CONTRACT NO. 1800

WET WEATHER PUMP STATION

ADDENDUM NO. 11

Contract: 1800
CAD File Name:
Date: 5/16/2025
Sheet: 104 of 405

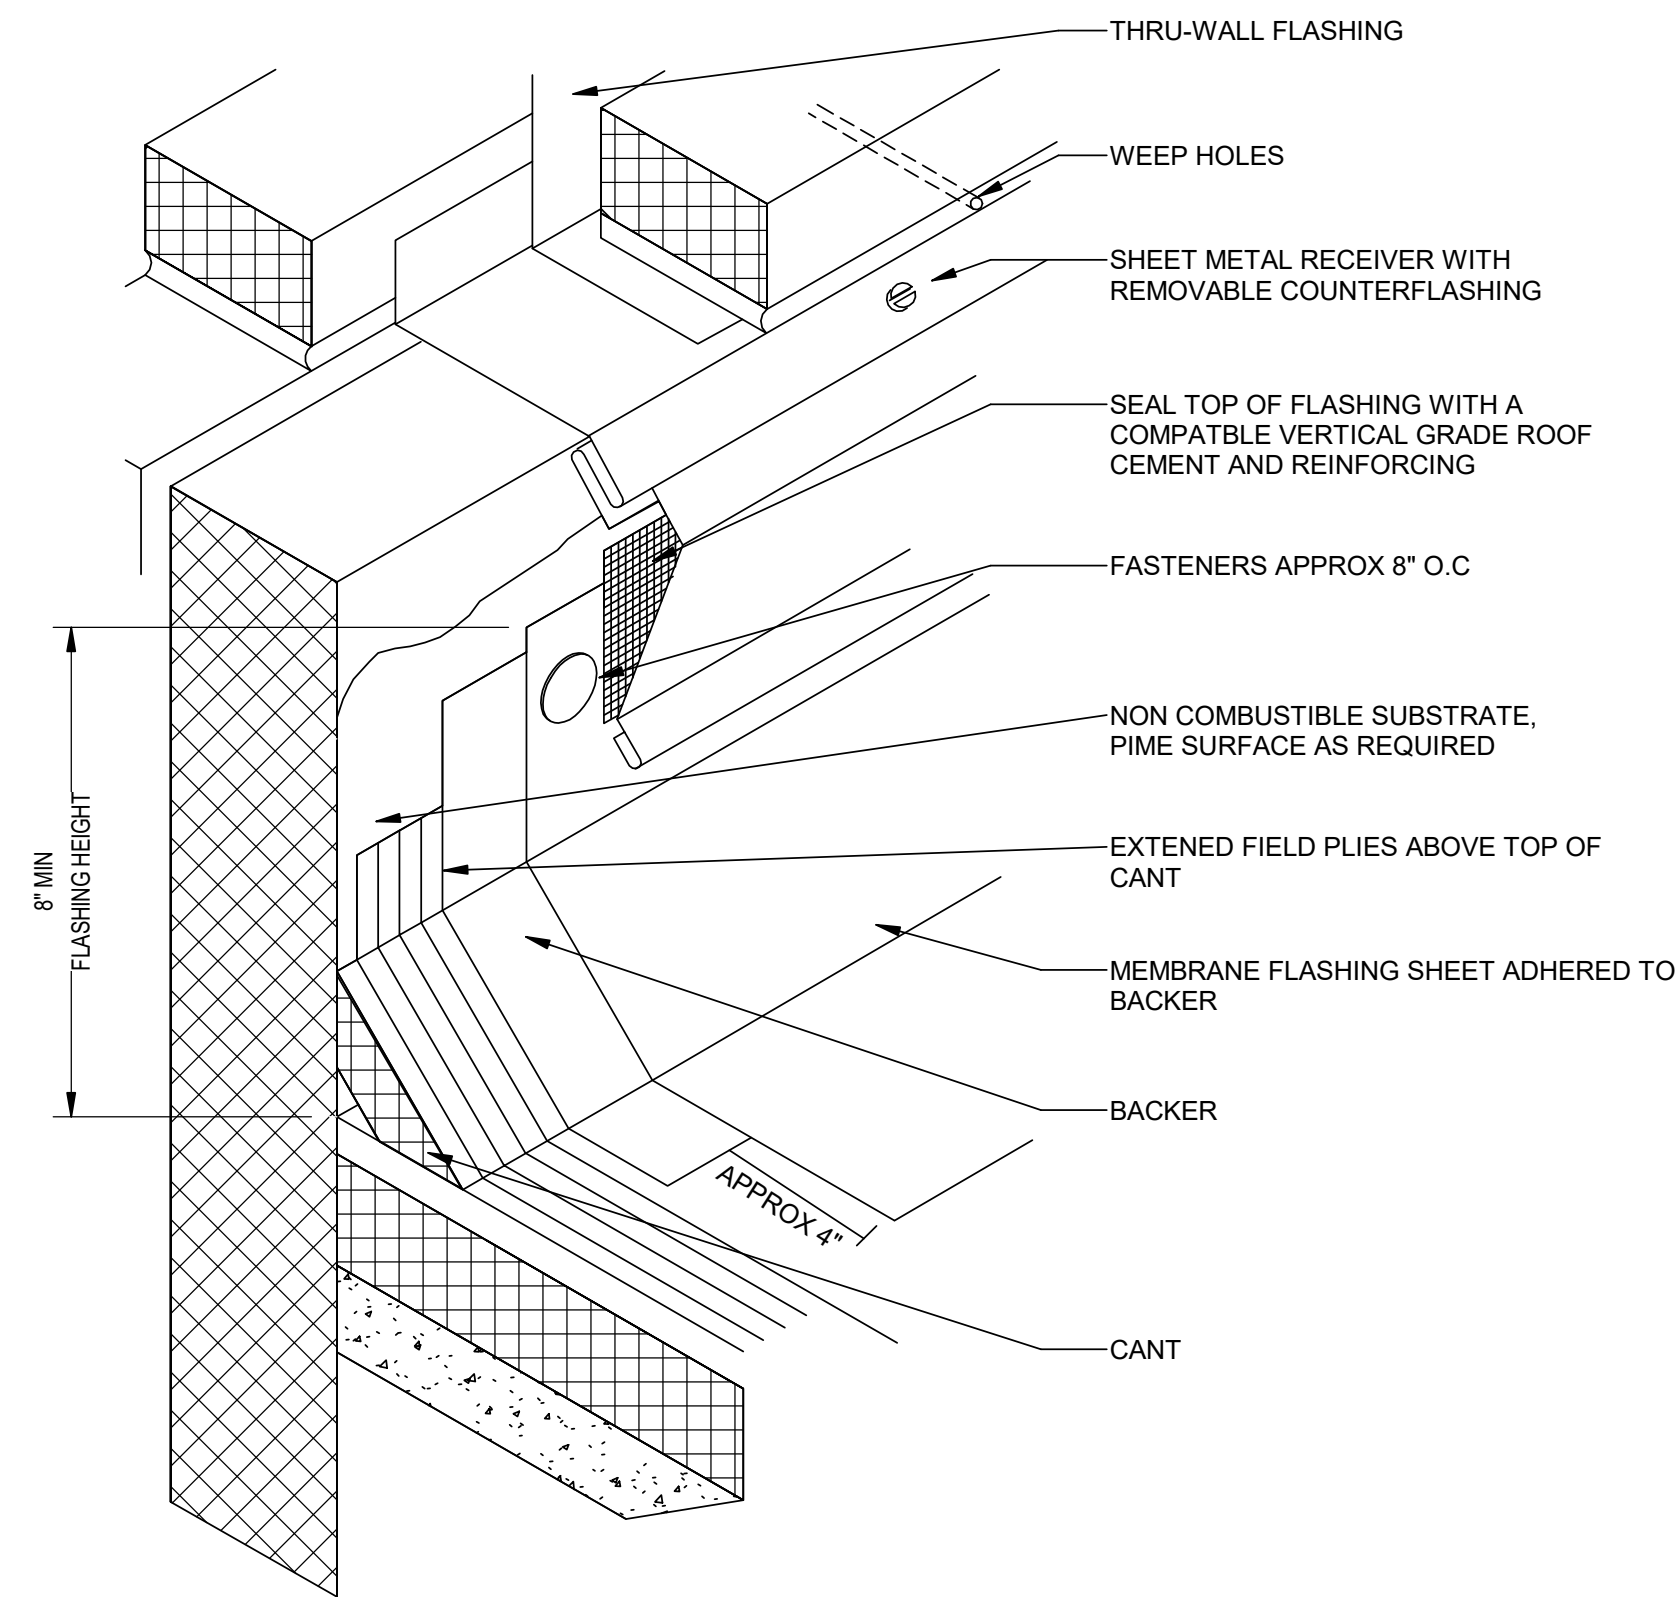
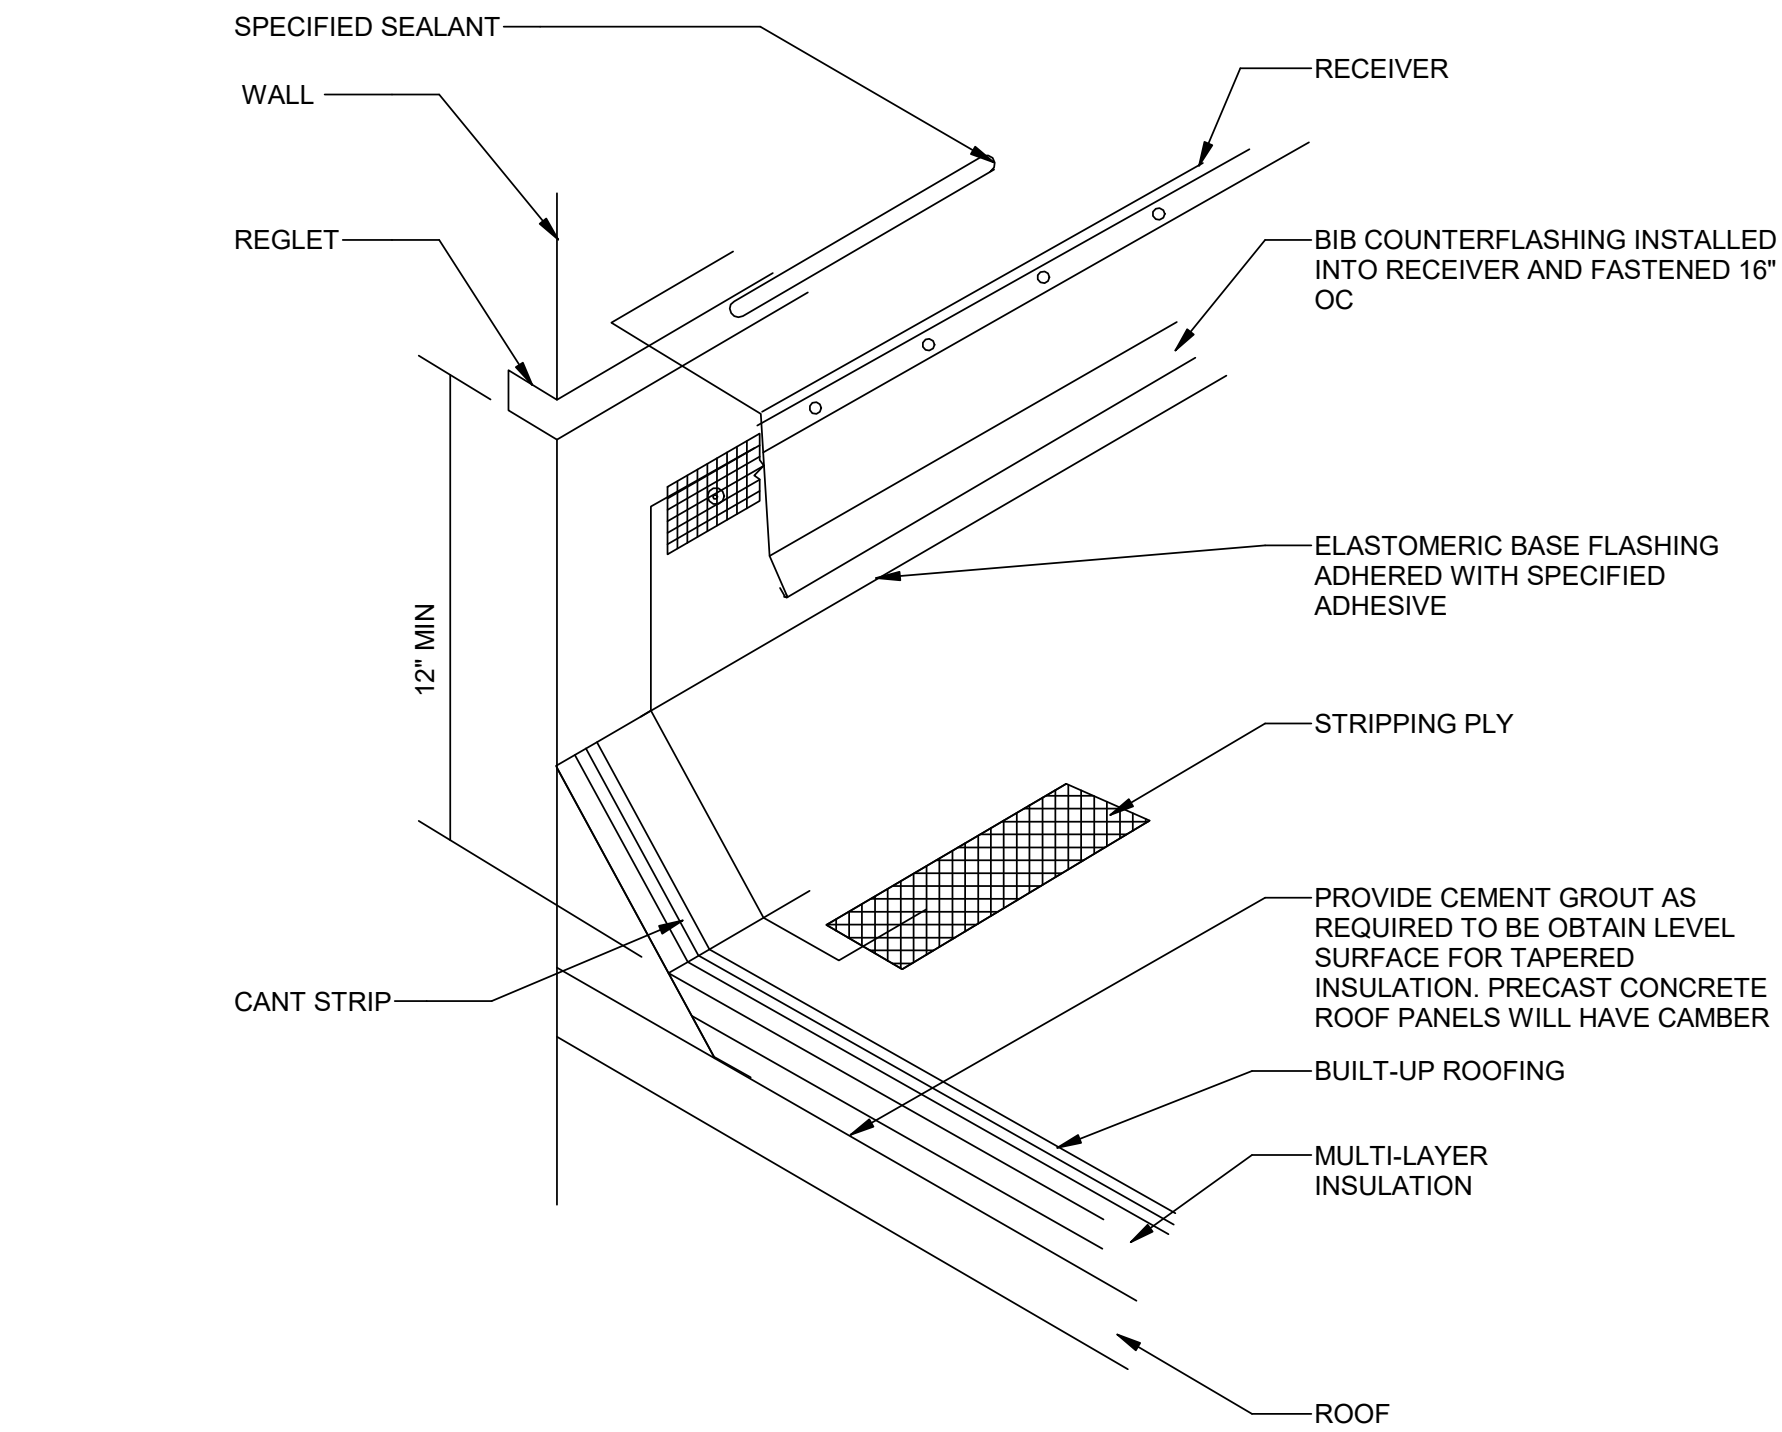
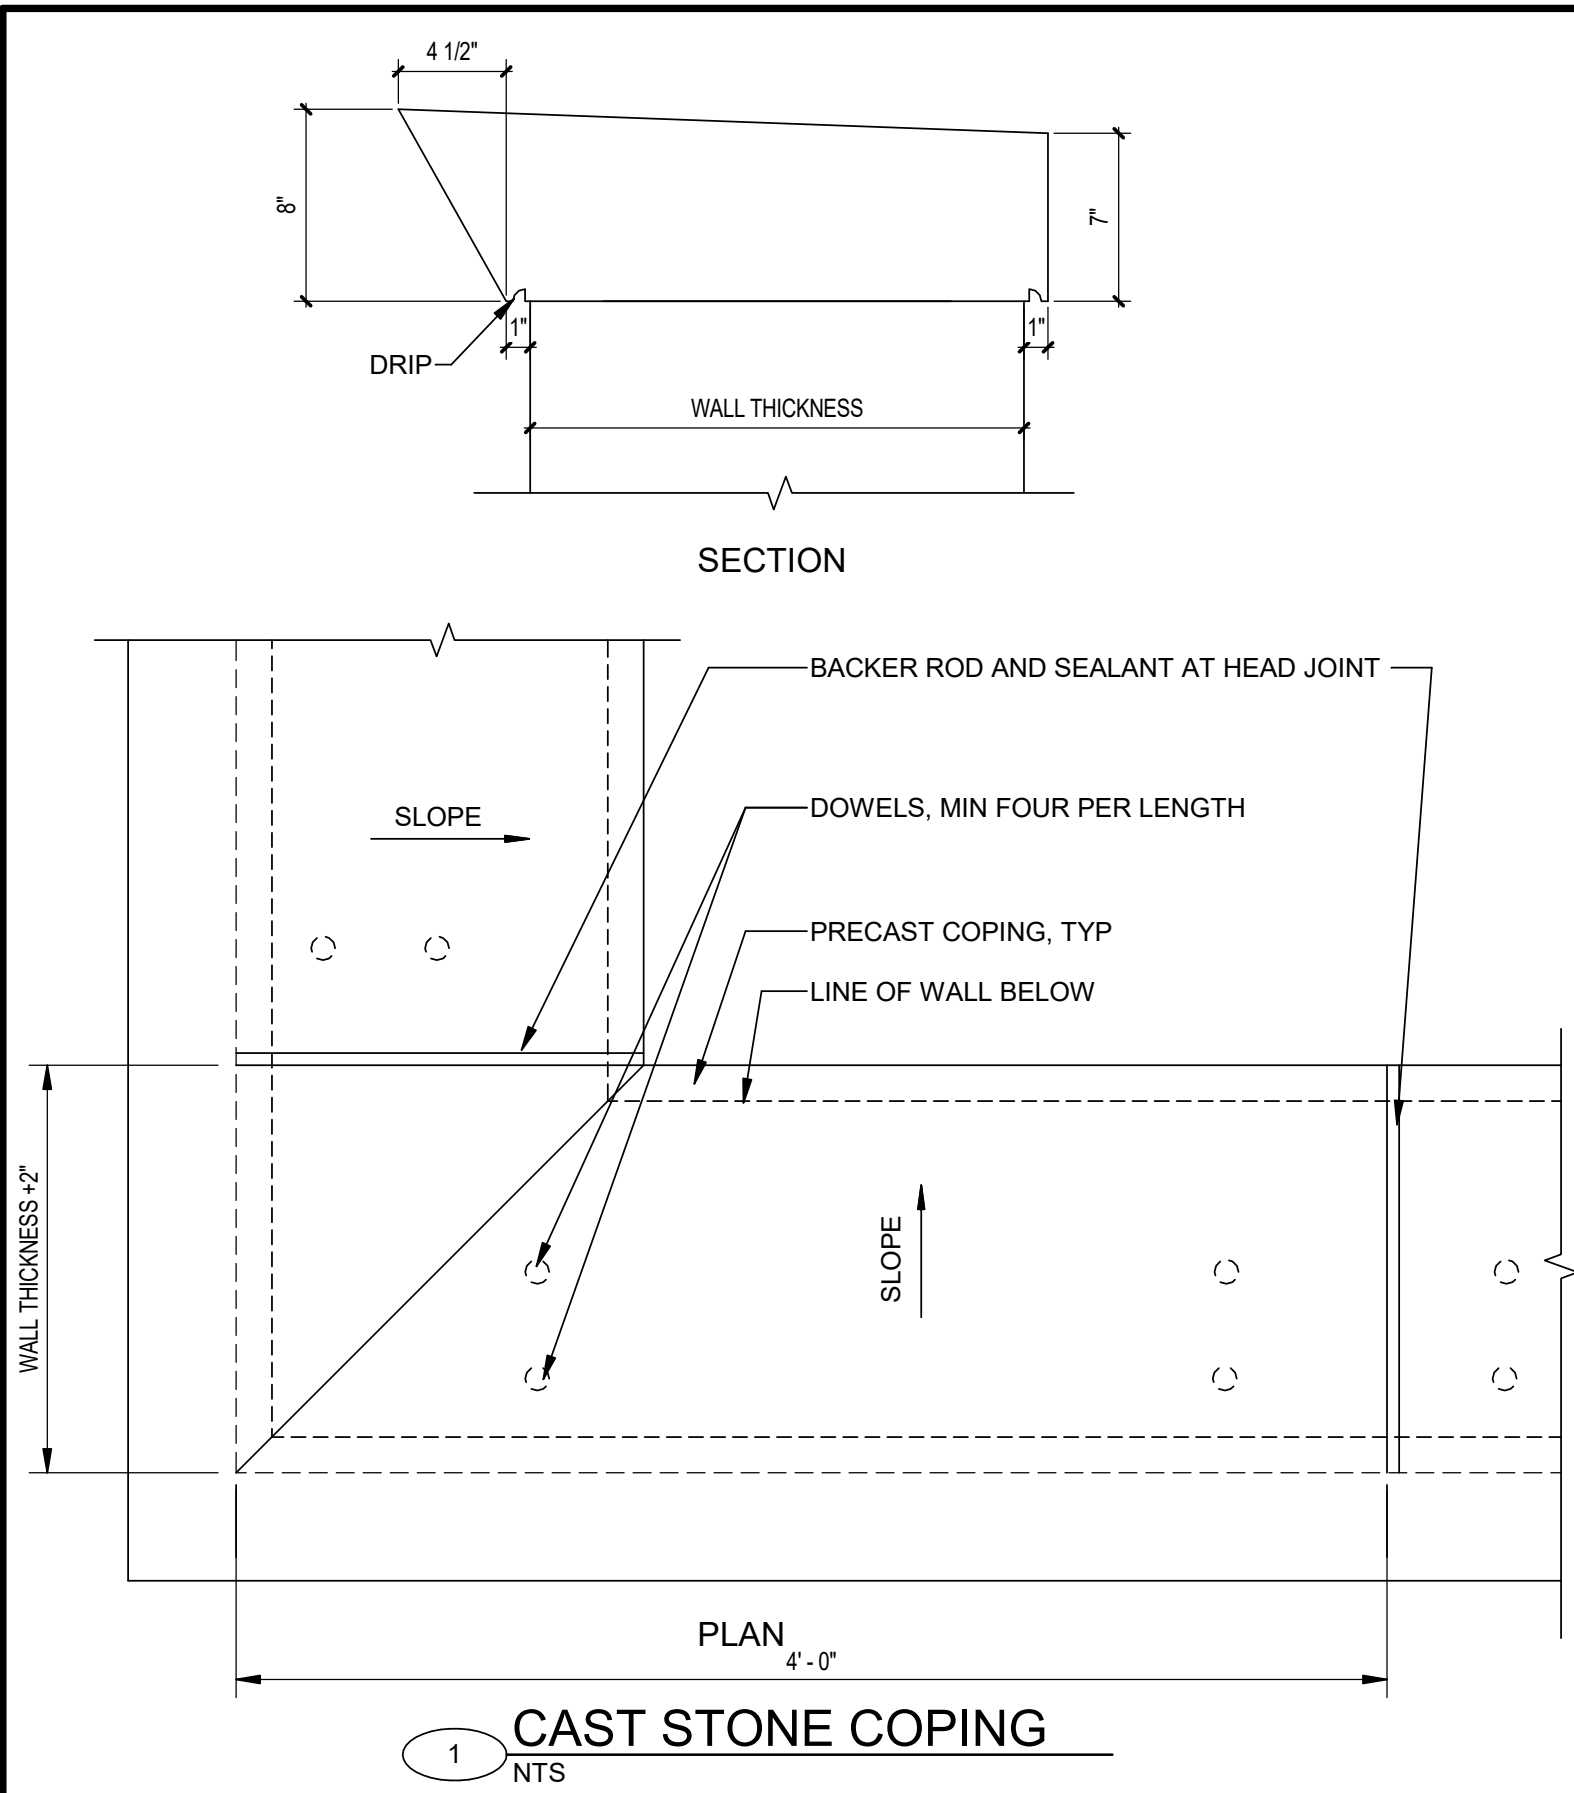
- Q34:** Detail 3/430-AD-04, 3/430-A-28 and 1/430-A-33, indicate the panel module width to be 2'-6". This however conflicts with the Specifications 2.03.1 which specifies the panel module to be 3'-0". Please clarify that the 2'-6" width in the Drawings is correct.

- A34:** The 3' Panel module noted in the specifications is the correct module. Refer to Items 4.10, 4.11, 4.12 and 4.13 of Addendum No. 11.
- Q35:** Drawing 430-AD-01 and numerous others shows the panel module thickness as 2". This however conflicts with the Specifications 2.03.4 which specifies the panel thickness to be 3" or to provide 4" when used in conjunction with Fire Resistant Wall Panels. Please clarify that the IMP panels, erected to masonry and/or concrete walls, are not intended to provide fire resistance and that the 2" panel thickness in the Drawings is correct.
